NucE 497 Fuel Performance Exam 2 covering modules 4 – 6

Name: 3

Question 1 (25 points):

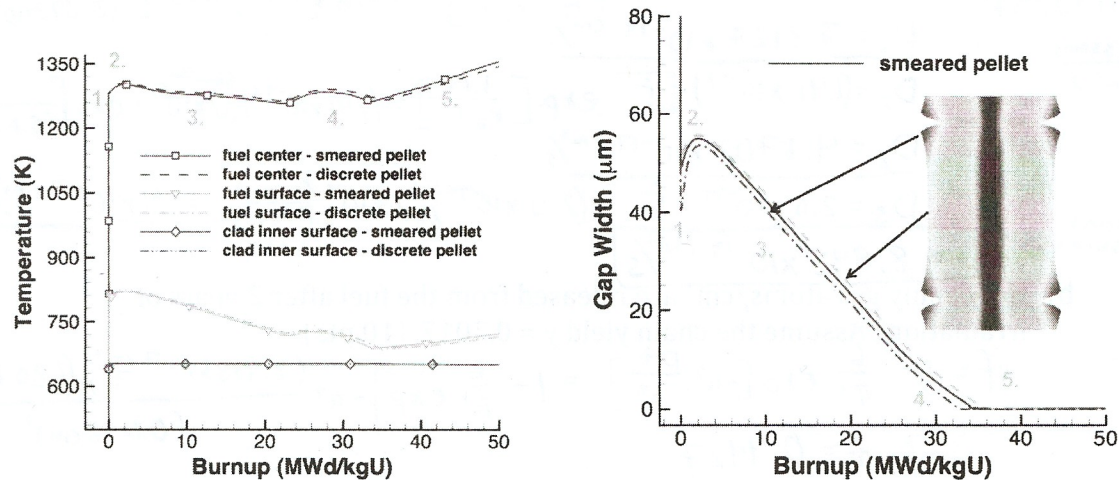
-5, 20/25

2. Due to densification, the gap width increases for a short period of time. Fuel pellets begin to fracture and the cladding is still not affected. Shown by gap width growth. -1, T increases

4. Fission products continue to force the pellet to swell, further decreasing the gap size. Fuel & Cladding creep come into effect. -2, T increases due to fission gas release before gap closure

5. End of life of fuel as the expansion of the pellets has completely closed the gap. Cladding corrosion has occurred and so have fractures in the cladding. -2, T increases due to decrease in fuel k with burnup
